Access Compliance Report

(Curb Ramps)

Intersection ID: 9653	Main Street: EDISON_ST	Cross Street: WOODWARD_AV	Location: NE
ADA ID: CDF1F98108D9	Ramp Type: Para	Initial Pass/Fail: Fail	Overall Compliance: No
Severity Score: 1.25			
Codes/Mitigation Info/Possible Solution		Field Measurements/Component Compliance

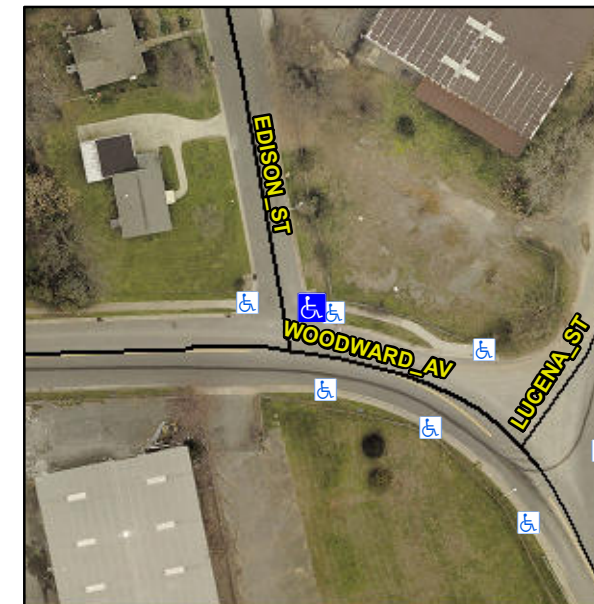
R304.5.3

Compliance	Description	Data	Compliance	Description	Data
N/A	Ramp Length LT (in)	63.5	N/A	Ramp Length RT (in)	35.0
Yes	Ramp Width LT (in)	59.0	Yes	Ramp Width RT (in)	62.0
Yes	Ramp Slope LT (%)	7.5	Yes	Ramp Slope RT (%)	7.4
No	Ramp XSlope LT (%)	3.8	No	Ramp XSlope RT (%)	3.3
N/A	Landing Length (in)	N/A	N/A	DWS Provided?	N/A
N/A	Landing Width (in)	N/A	N/A	DWS Contrast?	N/A
N/A	Landing Slope (%)	N/A	N/A	DWS Length (in)	N/A
N/A	Landing X Slope (%)	N/A	N/A	DWS Full Width?	N/A
N/A	Landing Curb? (Y/N)	N/A	N/A	DWS Offset (in)	N/A
N/A	Shared Landing?	N/A			
N/A	Gutter Ponding?	N/A	N/A	Gutter Slope (%)	N/A
N/A	Gutter Lip Ht (in)	N/A	N/A	Gutter X Slope (%)	N/A
N/A	Painted X Walk1?	No	N/A	Painted X Walk2?	N/A
	X Walk 1 Direction	To W		X Walk 2 Direction	N/A
N/A	X Walk 1 Width (in)	N/A	N/A	X Walk 2 Width (in)	N/A
	X Walk 1 Slope (%)	4.4		X Walk 2 Slope (%)	N/A
	X Walk 1 X Slope (%)	1.6		X Walk 2 X Slope (%)	N/A
N/A	Ramp inside XWalk1?	N/A	N/A	Ramp inside XWalk2?	N/A

Remove & Replace Entire Ramp.
